CITY OF KIRKLAND

NORTH ROSE HILL STORMWATER INFILTRATION WELL PROJECT JOB NO. 31-23-PW CIP NO. SDC-1320000

ADDENDUM NO. 1 TO THE PLANS, SPECIFICATIONS, PROPOSAL AND CONTRACT

UIC WELL DETAILS

REFERENCE SHEET NO.
SHEET 10 OF 15 SHEETS

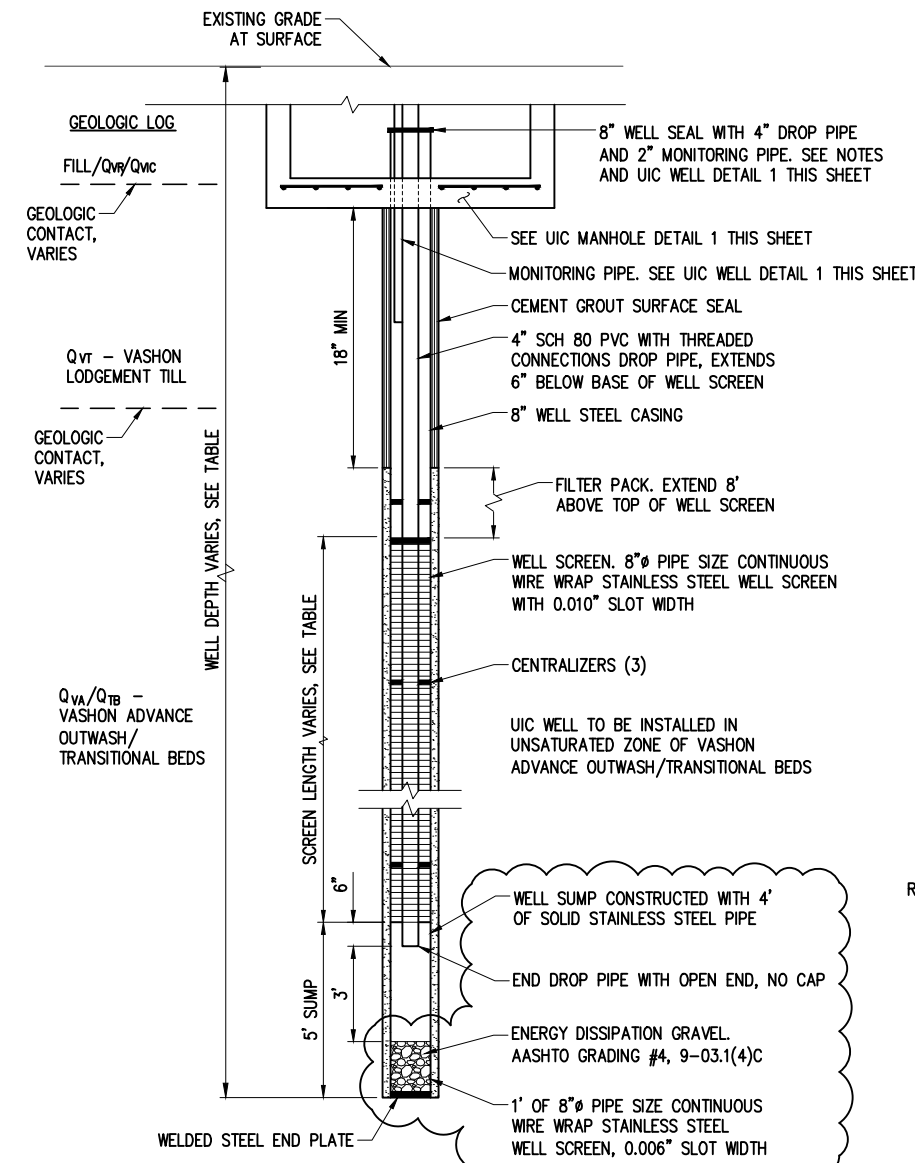
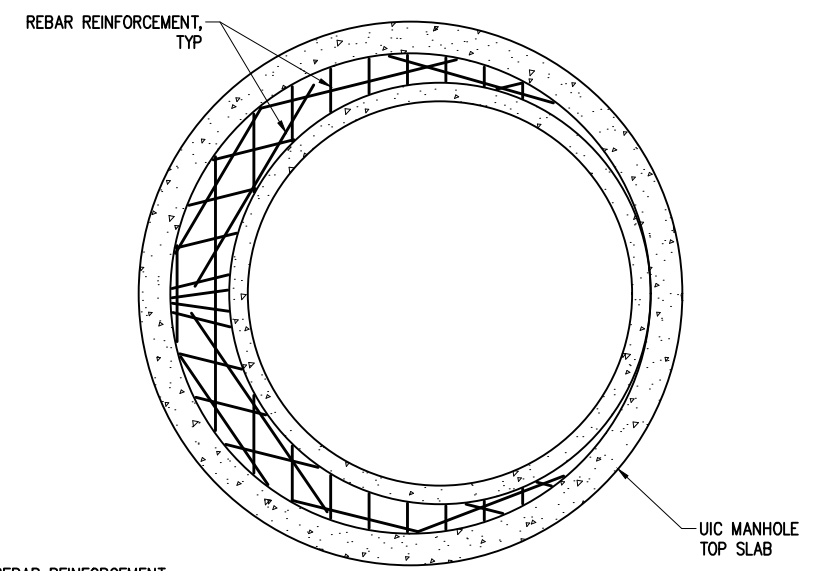
Item 1: Modifications to Plan Sheet 10 of 15

Remove and replace plan sheet 10 of 15 with attached. Minor modifications as shown in the drawings.

DATE	NO.	REVISION	BY
3/19/24	1	ADDENDUM #1 - UIC WELL DETAILS	DTG
